Lot 38 /

Model Caspian (42-3) Elev A

Colours Upgrade Report
Kings Ridge Print Date:20-Mar-13

FINAL STRUCTURAL REQUEST ACKNOWLEDGMENT

Basement Floor Elev. 'A'

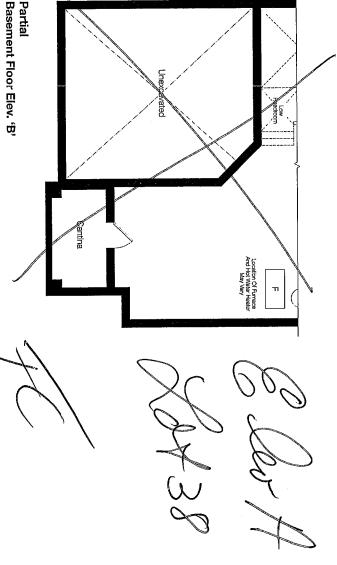
ID	Group	Description	Invoice	Date Ordered			
8826	INCLUDED IN OFFER	WINDOW LOFT - center window 48x54 approx. to loft area casement, 1 fixed and 1 operable	1710				
8827	INCLUDED IN OFFER	BASEMENT WINDOW - enlarge 4 basement windows to 24 x 30	1710				***************************************
8828	INCLUDED IN OFFER	MASTER ENSUITE - Frameless glass shower	1710				The state of the s
8829	INCLUDED IN OFFER	PLUMBING - water line to fridge	1710				
8830	INCLUDED IN OFFER	HVAC - rough in gas line to stove (leave electrical plug)	1710				
8831	INCLUDED IN OFFER	STRUCTURAL - kitchen install beam to carry floor joists spanning from interior point load to exterior point load.	1710				
8832	INCLUDED IN OFFER	WINDOWS STRUCTURAL CHANGES - shift and space dining room window approx 27 inches toward front of house. Move wall off kitchen down approx 27 inches. Additional tile to kitchen (to be selected from builders standard samples) **Any extra cabinetry to be paid for at time of colour appointment. No cabinet prices are included in this price	1710

Second Floor Elev. 'A'

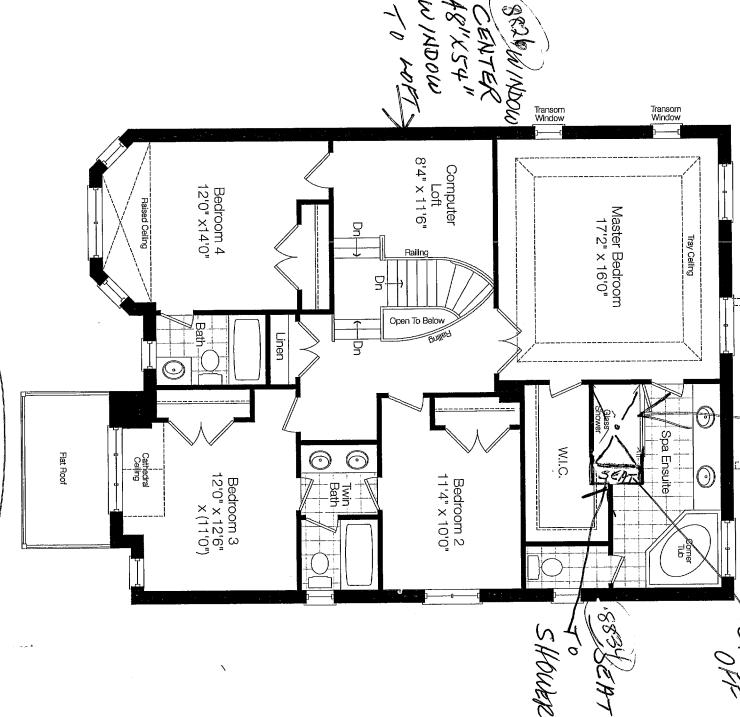
8833	INCLUDED IN OFFER	MASTER ENSUITE STRUCTURAL - extend shower in master ensuite 2 feet and square off	1710		(2 feet)		
8834	INCLUDED IN OFFER	MASTER ENSUITE - add shower seat to master ensuite	1710				
8874	INCLUDED IN OFFER	LOT SPECIFIC PLAN *additional square footage *corner upgrade	1710			u*

Partial Master Bedroom Door & Window Location For Opt. Balcony Condition Tray Ceiling trasser (683) Opt. Balcony SSESSAME 0 2 Hower Elev. B 2717 sq. ft. Elev. A 2745 sq. ft. (8838) QN3 SOUARE Howax
